IEEE Std C37.60™-2003/Cor 1-2004
(Corrigendum to
IEEE Std C37.60-2003)

IEEE Standard Requirements for Overhead, Pad-Mounted, Dry Vault, and Submersible Automatic Circuit Reclosers and Fault Interrupters for Alternating Current Systems up to 38 kV—Corrigendum 1

This Corrigendum to IEEE Std C37.60-2003 includes both technical and editorial corrections to the original document.

Figure B.1—Surge test circuit

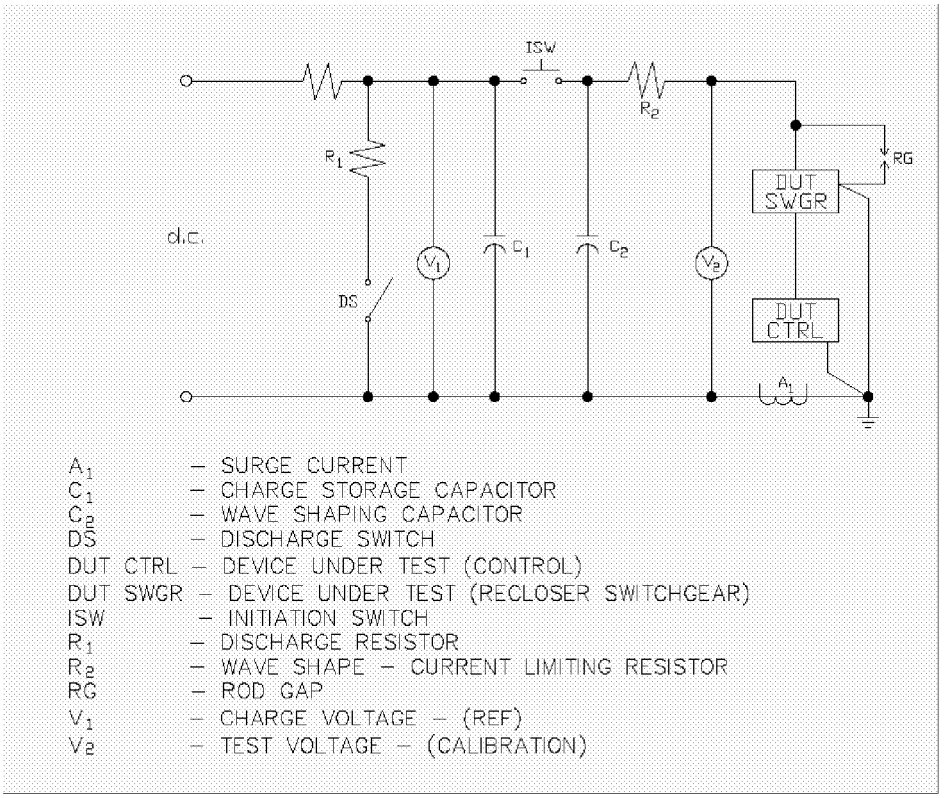
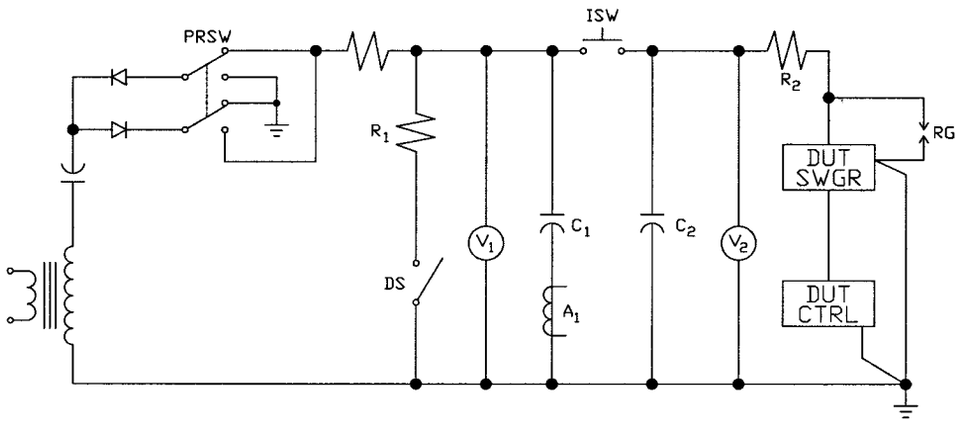
In Annex B, Figure B.1 was changed and simplified.

Replace Figure B.1 with the following:
